Access Compliance Report Public Rights-of-Way (Curb Ramps)

Main Street: HAZARD_AVE		Cross Street: NEWLAND_ST		Location:	SW
ADA ID: RPAT220221150412	Ramp Type: Type 4 - Parallel	Initial Pass/Fail: Pass	Overall Compliance: No	Severity Score:	5
Codes/Mitigation Info/Possible Solution			Field Measurements/Component Compliance

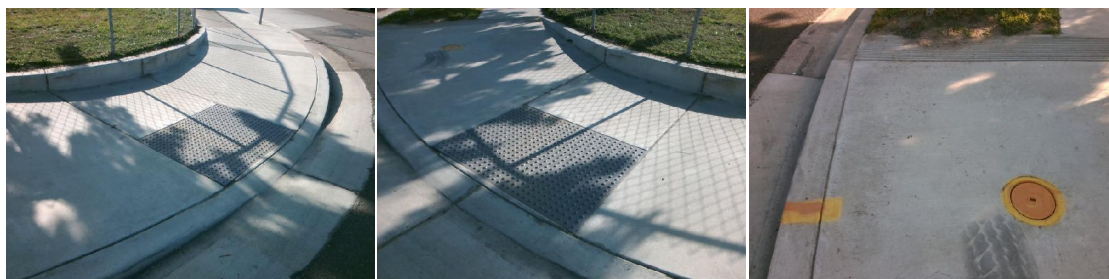
N/A	Ramp Inside Crosswalk 1	N/A	N/A	Ramp Inside Crosswalk 2	N/A
	Crossing 1 Slope (%)	5.6		Crossing 2 Slope (%)	N/A
	Crossing 1 Cross Slope (%)	0.1		Crossing 2 Cross Slope (%)	N/A
Yes	Gutter Ponding	No	Yes	Curb Slope	6.8
Yes	Gutter Lip Height (in)	0		Road Run Slope (%)	N/A
No	Gutter Run Slope (%)	9		Road Cross Slope (%)	N/A
Yes	Gutter Cross Slope (%)	0.1	Yes	Perpendicular Joint Present	Yes
Yes	Overall Surface Condition	Acceptable			
	Cross Gutter Present?	No		Spandrel Present?	No
	Replace Cross Gutter?	N/A		Replace Spandrel?	N/A

Remove & Replace Gutter. Utility Present.

R304.5.4, STD 1115
